Groundwater Application Review Summary Form

Application # LL-1976
GW Reviewer Grayson Fish Date Review Completed: 5/14/2024
Summary of GW Availability and Injury Review:
Groundwater for the proposed use is either over appropriated, will not likely be available in the amounts requested without injury to prior water rights, OR will not likely be available within the capacity of the groundwater resource per Section B of the attached review form.
Summary of Potential for Substantial Interference Review:
There is the potential for substantial interference per Section C of the attached review form.
Summary of Well Construction Assessment:
☐ The well does not appear to meet current well construction standards per Section D of the attache review form. Route through Well Construction and Compliance Section.
This is only a summary. Documentation is attached and should be read thoroughly to understand the basis for determinations and for conditions that may be necessary for a permit (if one is issued).

TO: FROM		r Rights Secti ndwater Secti	on on		Grayson F		Date _		5/14/2	2024		
SUBJE	CT: Appli	cation <u>LL-19</u>	76_	S			w of					
issued o	on 8/2/2019. LL	-1540 expires		s ap	plication is

Water-Level Measurements in Nearby Wells

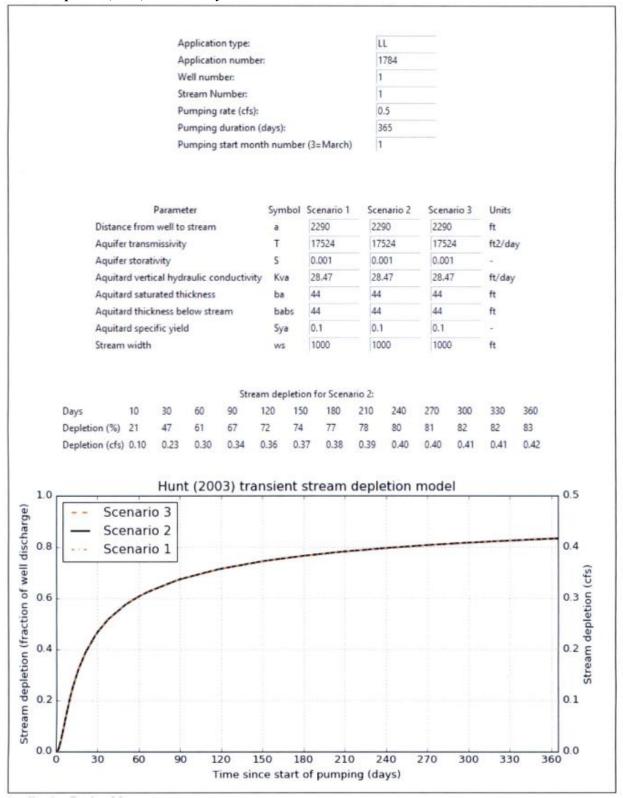
Hyd sign is no	drographs from the proposed POA KLAM 11674 as well as nearby wells KLAM 11656 and KLAM 50315 do not show ificant groundwater level declines over the available periods of record indicating that groundwater storage in the vicinity of over appropriated. Given the vicinity of KLAM 11674 to Upper Klamath Lake, it is likely that the predominate source vater to this well would be though capture of surface water.
